5.0 DESIGN FEATURES

GGNS
~~BWR STS I~~

MISSISSIPPI POWER & LIGHT COMPANY
 GRAND GULF NUCLEAR STATION
 EXCLUSION AREA AND GASEOUS
 EFFLUENT RELEASE POINTS
 FIGURE 5.1.1-1

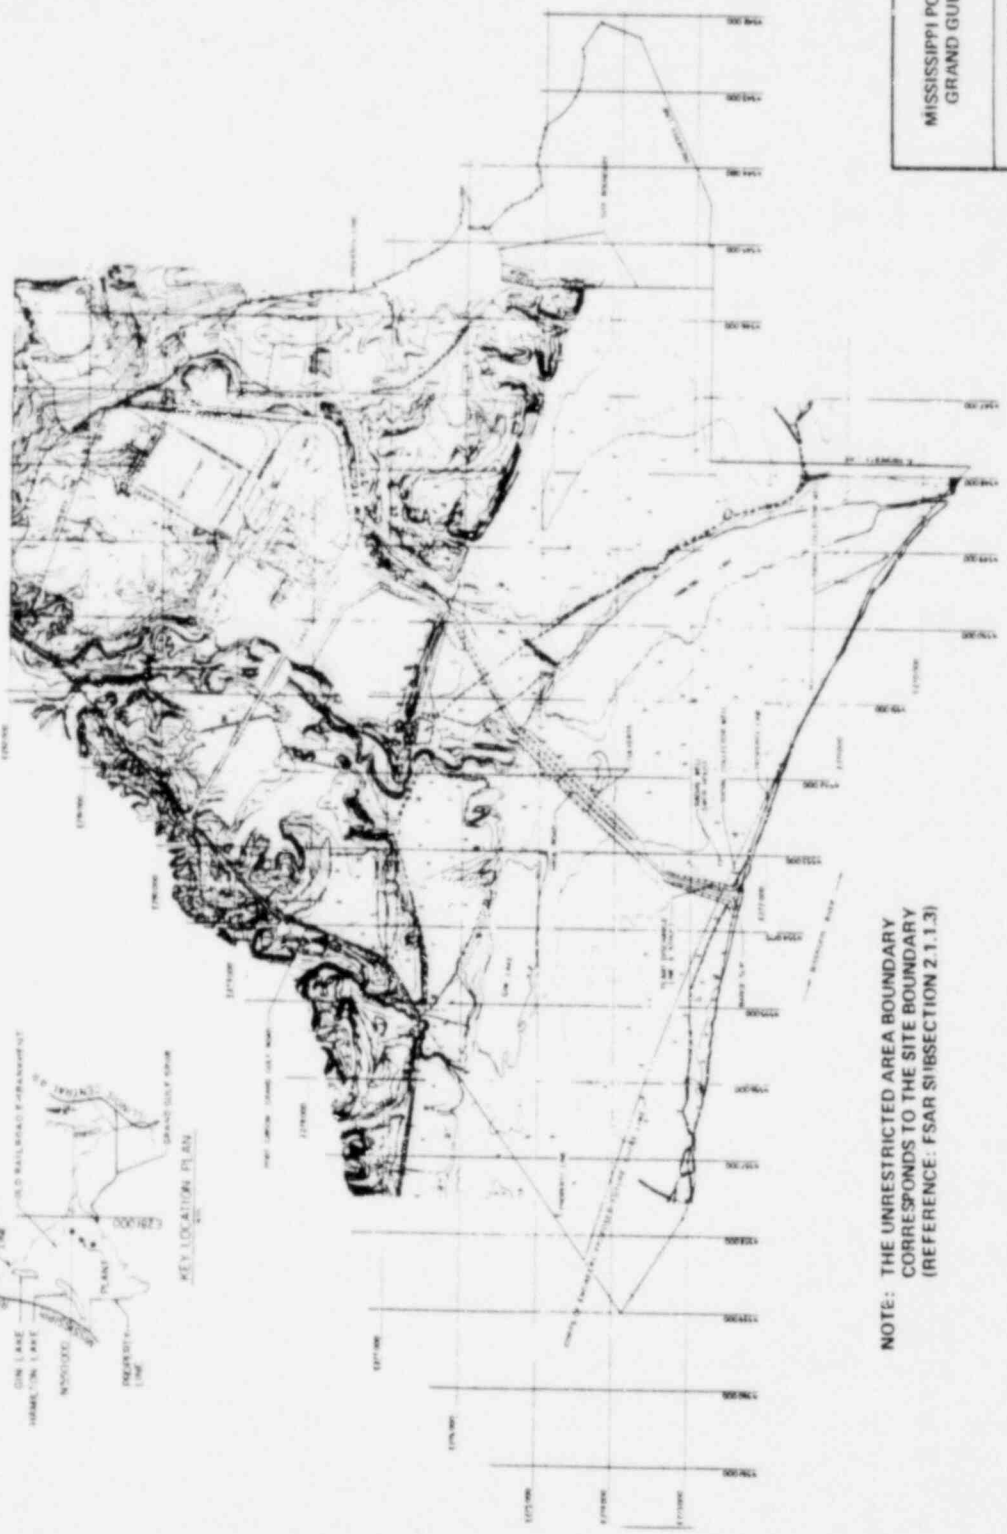
5.1.3 The ~~site~~ boundary for gaseous effluents shall be as shown in Figure ~~5.1.3-1~~. The gaseous effluent release points are shown in Figure 5.1.1-1. ^{5.1.4-1}

FIGURE 5.1.4.1

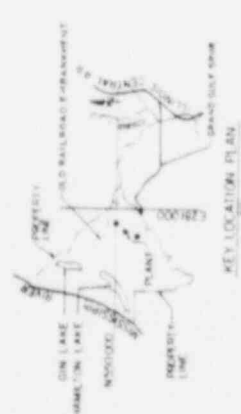
~~SITE~~ BOUNDARY FOR GASEOUS EFFLUENTS

unrestricted area

~~SITE~~ BOUNDARY FOR LIQUID EFFLUENTS

unrestricted area

5.1.4 The ~~site~~ boundary for liquid effluents shall be as shown in Figure 5.1.4-1.
